VILLAGE OF ARLINGTON HEIGHTS **STAFF DEVELOPMENT** **COMMITTEE REPORT**

Project Number: PC 20-016
Project Title: 703-723 W. Algonquin Rd. PUD
Amendment
Address: 703-709 & 713-723 W. Algonquin Rd.
PIN's: 08-16-102-038, 08-16-102-036

To: Plan Commission
Prepared By: Sam Hubbard, Development Planner
Meeting Date: February 24, 2021
Date Prepared: February 19, 2021

Exhibit 3 – Landscape Island Barrier Concept

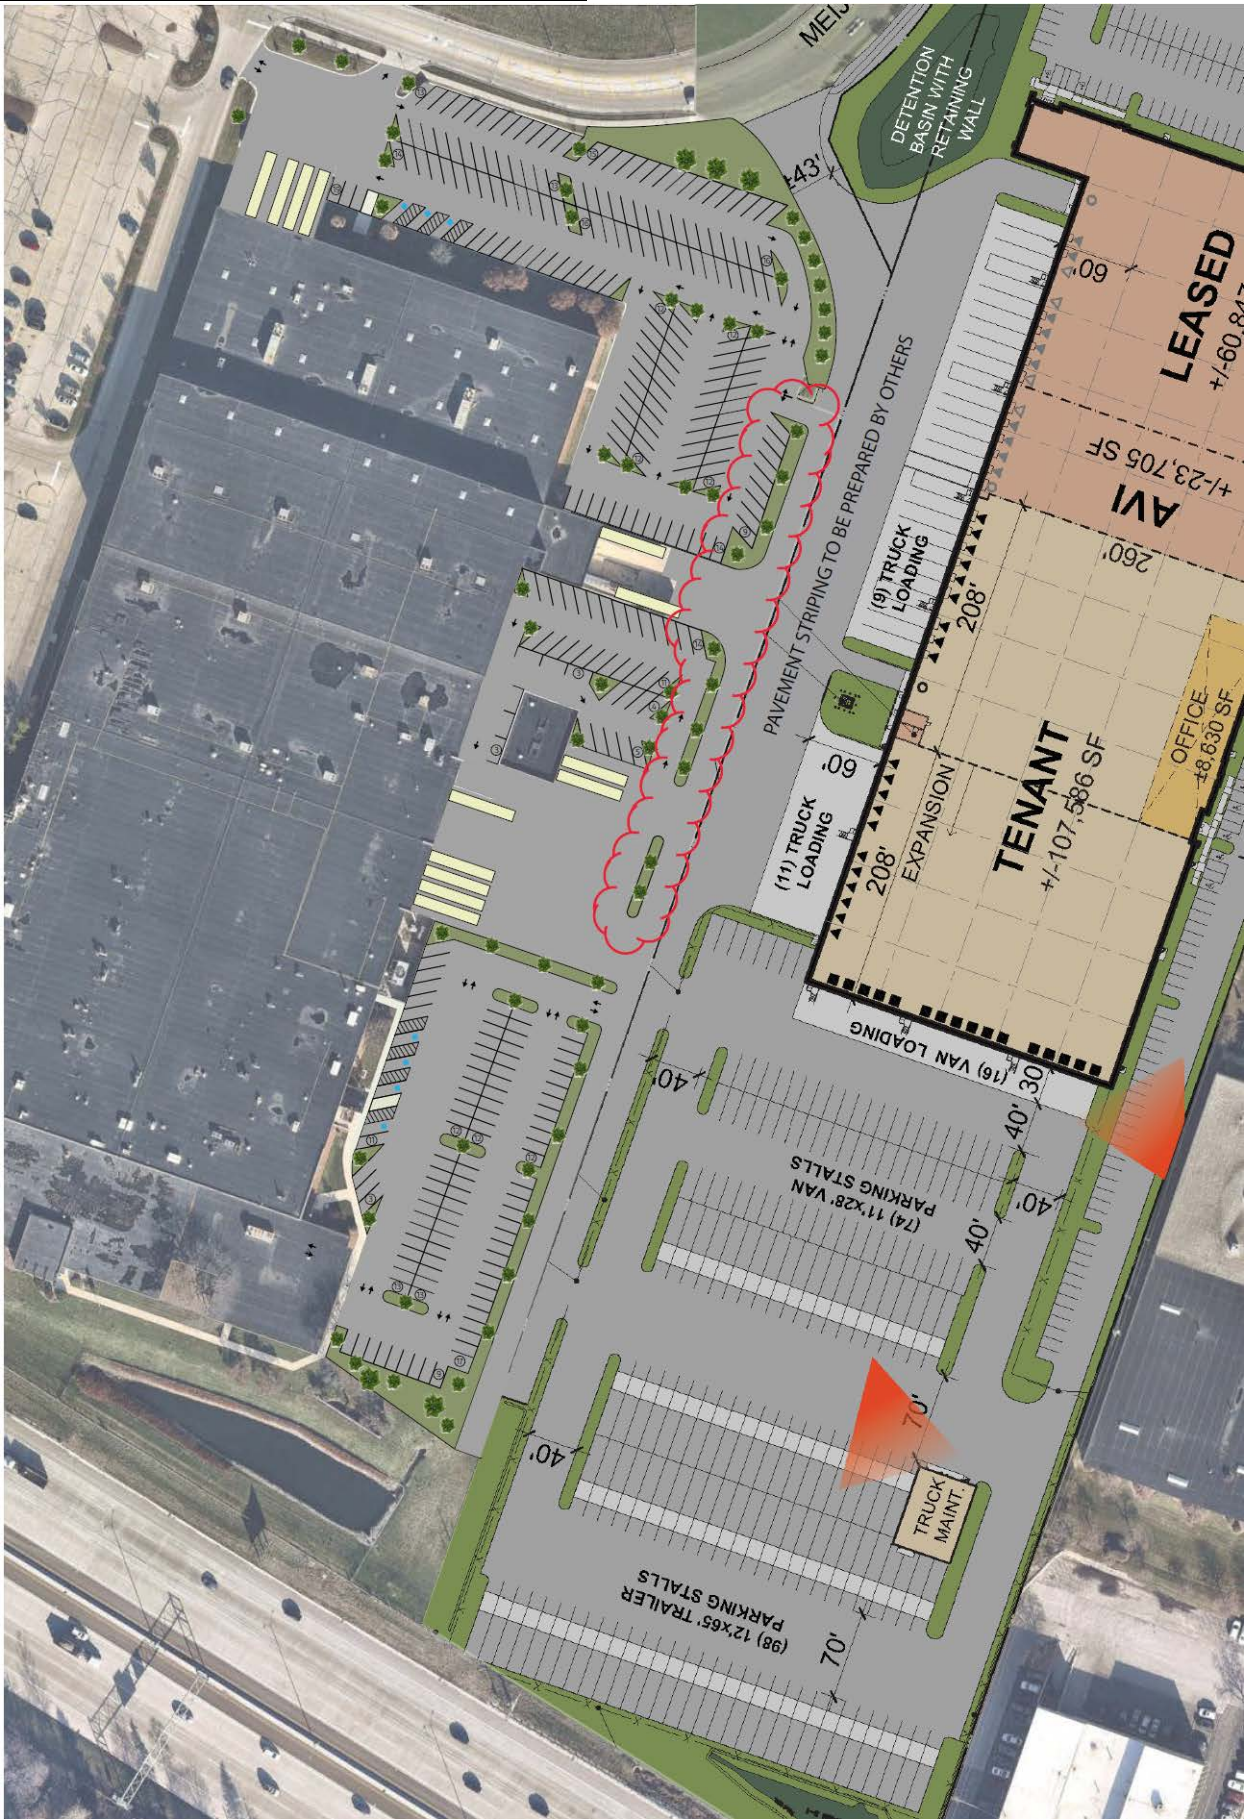
7. At the expense of the petitioner, a landscaped island (inclusive of landscaping) or similar barrier feature in the general location as shown in red on **Exhibit 3**, shall be constructed to prevent vehicle movements from encroaching outside of the easement area and into the Weber Packaging Solutions property. Final design of said feature shall be as determined by the Village in cooperation with the Petitioner and Weber Packaging Solutions. This shall only be required if approved by Weber Packaging Solutions.
